Stellaris® LM3S9B92 RevB1 Errata

This document contains known errata at the time of publication for the Stellaris® LM3S9B92 microcontroller. The table below summarizes the errata and lists the affected revisions. See the data sheet for more details.

Figure 1. Timing Differences Between Rev B and Rev C Devices**Workaround:**

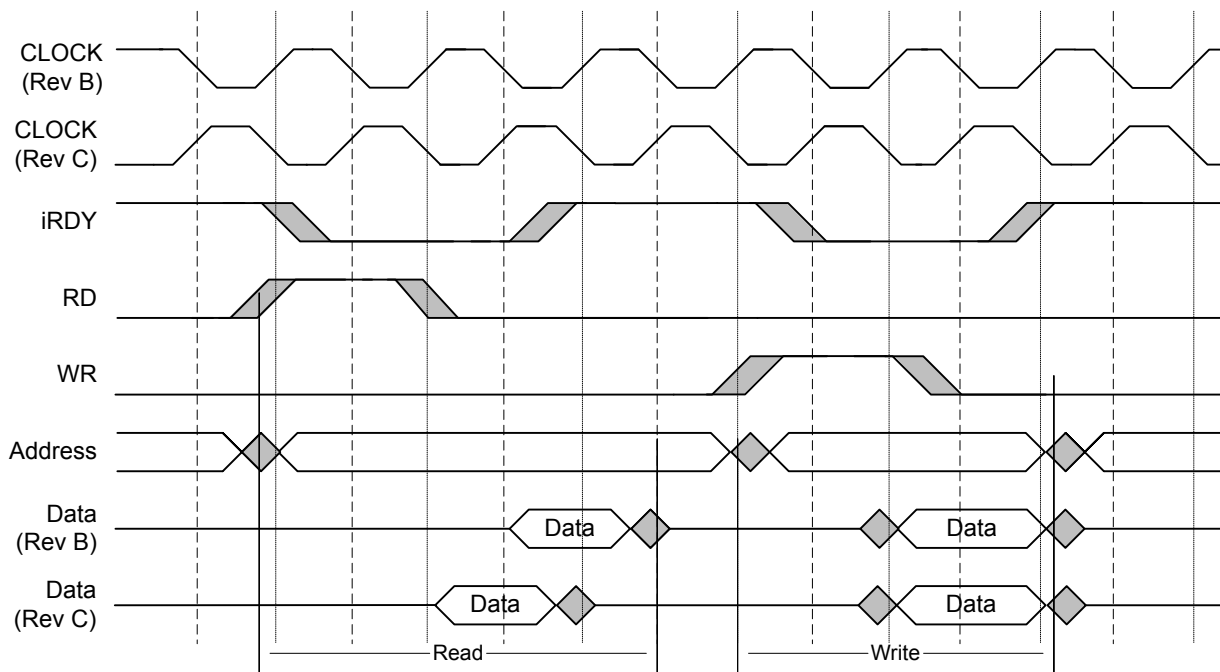
The clock signal that is output on the EPIOS31 signal in General-Purpose mode is inverted. Figure 1 on page 13 shows the timing differences between Rev B parts and Rev C parts.

Use the opposite edge for timing when designing with this interface. During read cycles, ensure that the data meets set up and hold times for the appropriate edge as shown in the diagram above.

Figure 7. Configuration of External Regulator

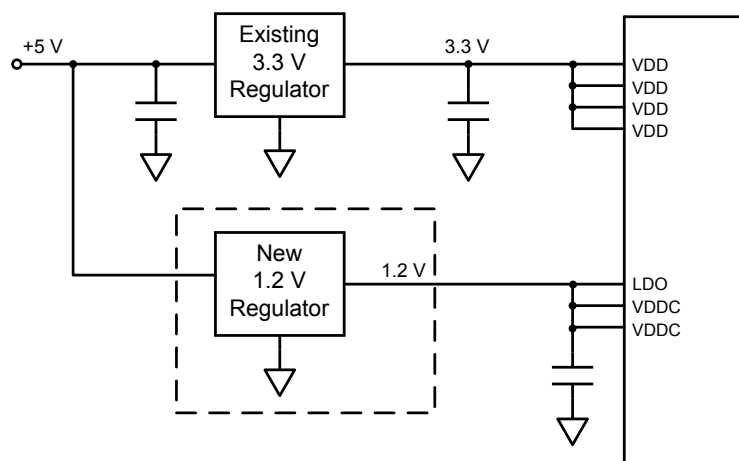
Incorrect power sequencing during power up can disrupt operation and potentially cause device failure.

V_{DDC} must be applied approximately 50 μ s before V_{DD} . Normally V_{DDC} is controlled by the part's internal LDO voltage regulator. The workaround requires the addition of an external regulator (see Figure 7) to ensure that V_{DDC} sequencing requirements are met (see Figure 8). A recommended regulator is the TI TPS73101DBVR.
